SHAFER ZAHNER ZAHNER
OFFICE OF ARCHITECTURE

GS# 104-215 Jones Hall Interior Renovations (RE-BID)
Mississippi University for Women

Addendum No. 3

SITE PLAN: Fencing extents and contractor access

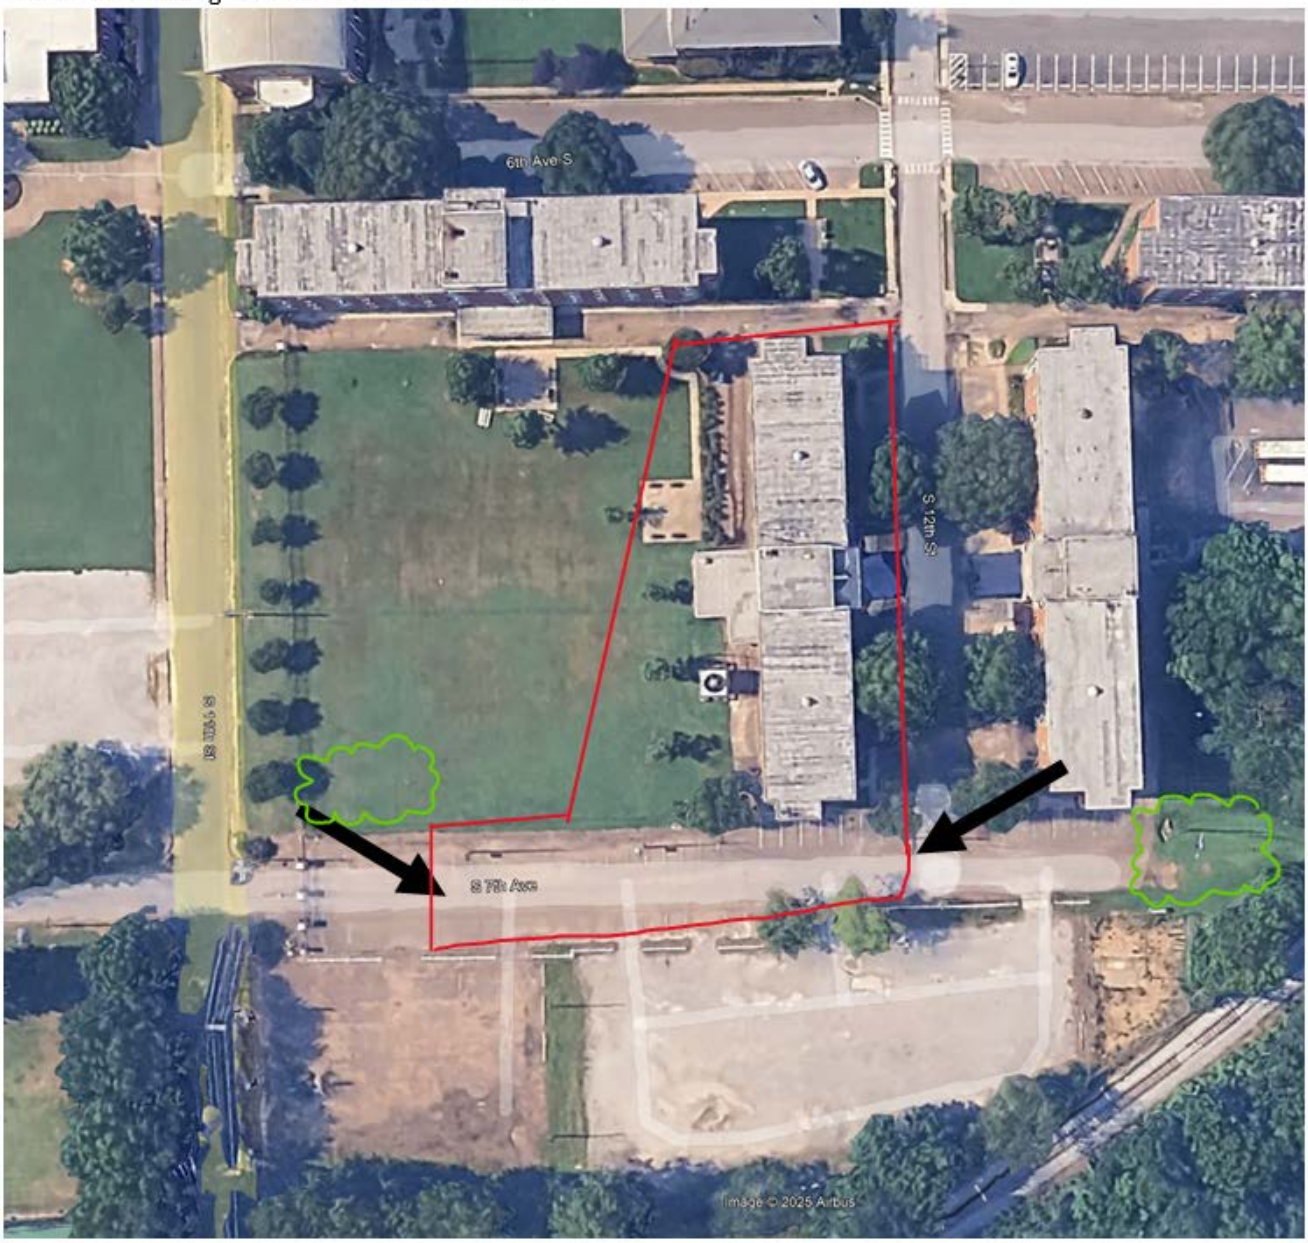
1. Clarifications:
    a. The project fencing and laydown extents did not print correctly. See attached diagram in color – approximate fencing extents are shown in RED. Laydown for concurrent chiller project are shown in GREEN. Proposed contractor gate locations are shown with ARROWS.

SHEET E301

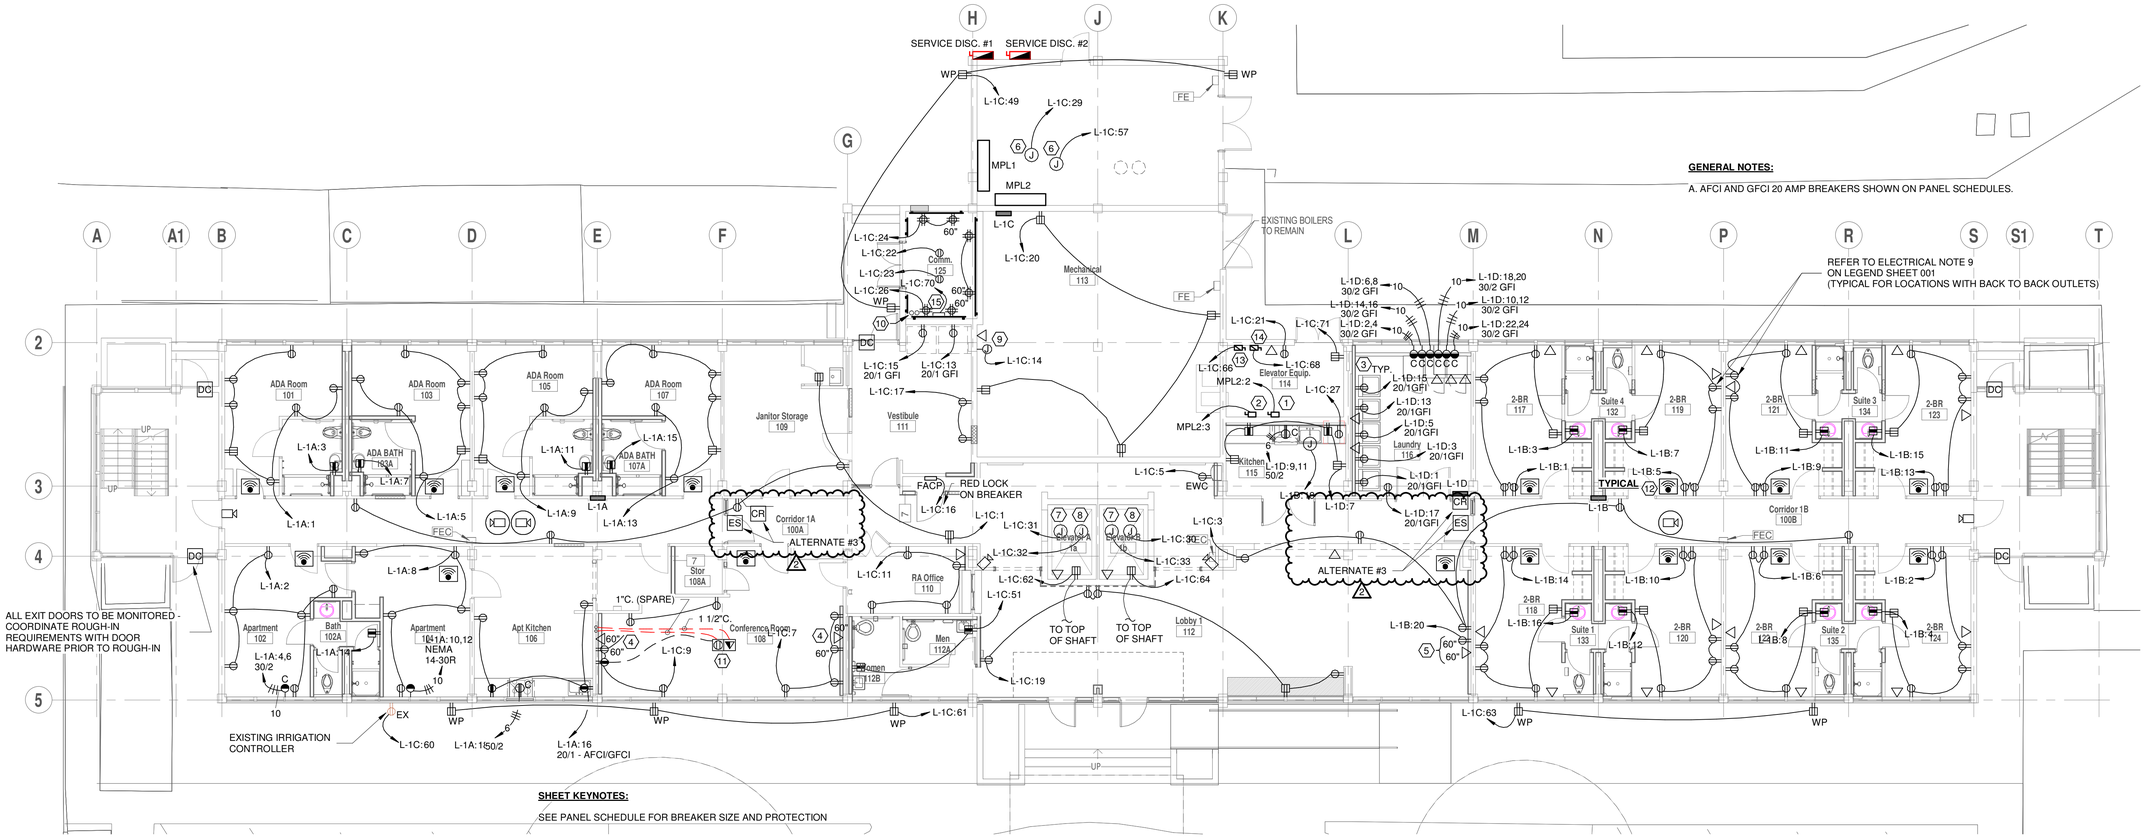
d. Sheet E301: Revise Note I for security cameras; Revised card reader location for interior door. Revised reference to Alternate #3 for interior doors. See attached revised E301.

i. Note: The EC is only responsible for all of the pathways. State ITS will provide voice data cabling and equipment. State ITS will provide data cabling for security cameras. The EC should provide all cabling for card readers.

I. THE FOLLOWING ARE THE RESPONSIBILITIES FOR THE AUXILIARY SYSTEMS SCOPE:

- VOICE DATA - EC PROVIDES RACEWAYS AND BOXES. STATE ITS PROVIDES EQUIPMENT, CABLING, AND DEVICES.
- (2) SECURITY CAMERAS - EC PROVIDES RACEWAYS, AND BOXES. STATE ITS WILL PROVIDE CABLING. OWNER IS PROVIDING DEVICES AND EQUIPMENT.
- ACCESS CONTROL - EC SHALL PROVIDE A COMPLETE SYSTEM INCLUDING RACEWAYS, DEVICES, CABLING, EQUIPMENT, ETC. SYSTEM SHALL BE BY GALAXY ACCESS CONTROL. SYSTEM SHALL INTERFACE WITH EXISTING CAMPUS ACCESS CONTROL SYSTEMS.

SHEET E302

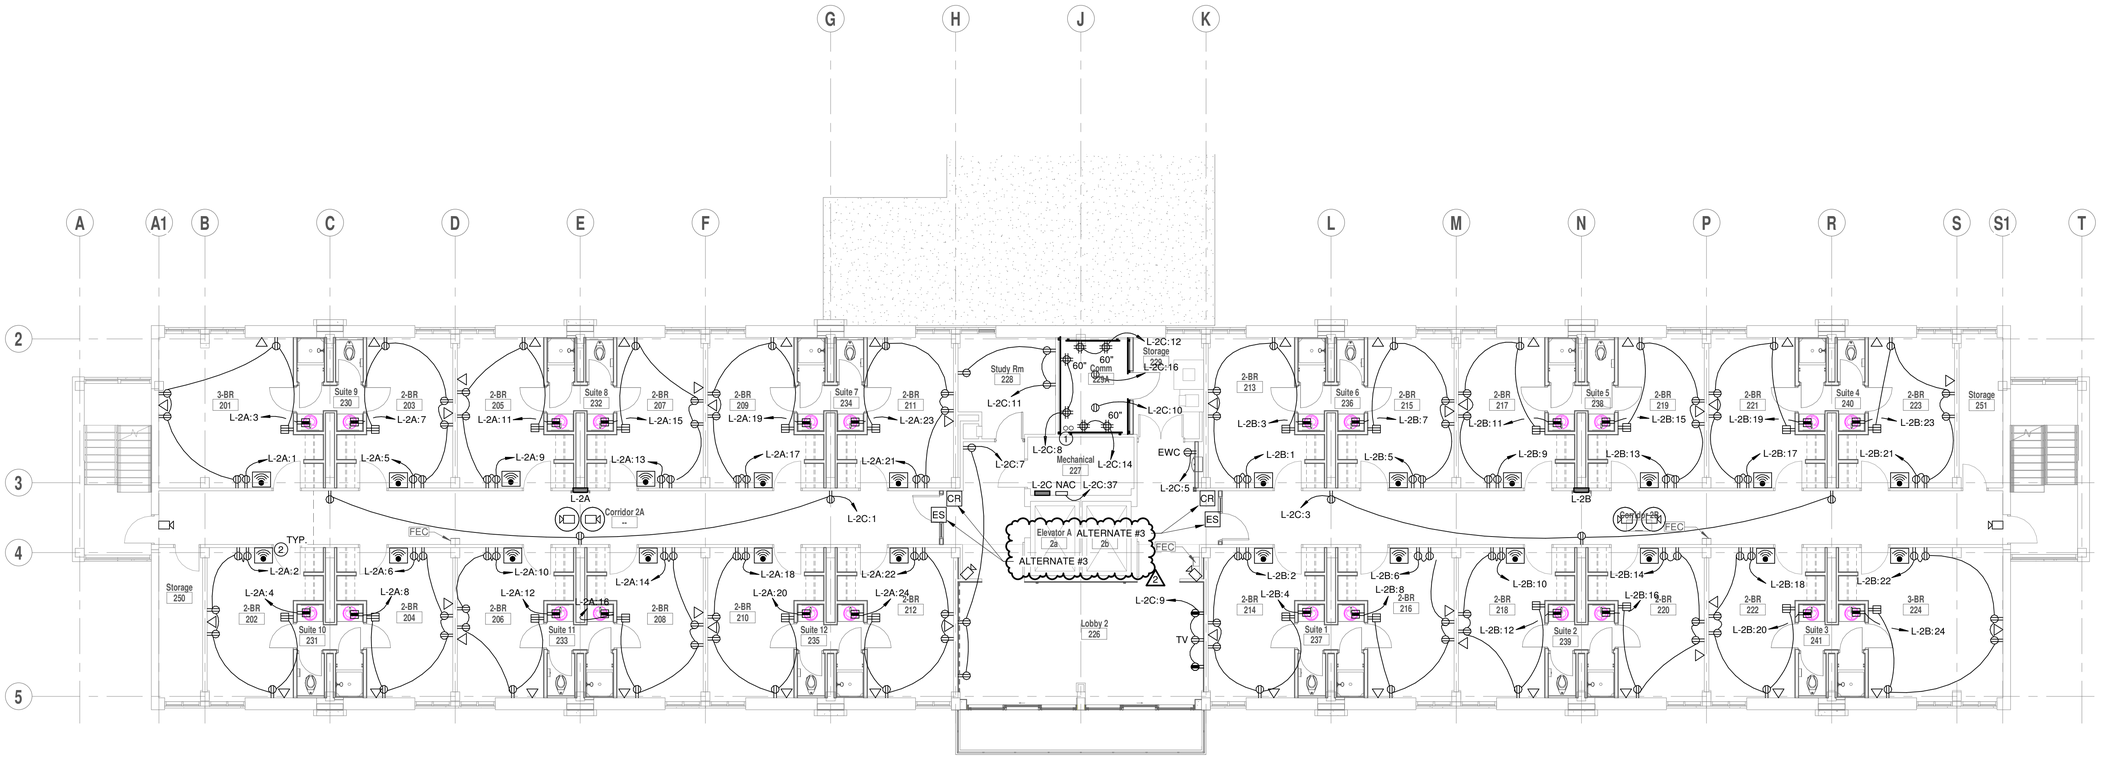
e. Sheet E302, E303, E304: Revised reference to Alternate #3 for interior doors. See attached revised E301.
        i. Note: The base bid is rough in for all doors (interior and exterior) as well as complete system with components, devices, cabling, equipment, etc. for exterior doors. Alternate 3 includes the base bid plus complete system with components, devices, cabling, equipment, etc. for both interior and exterior doors.
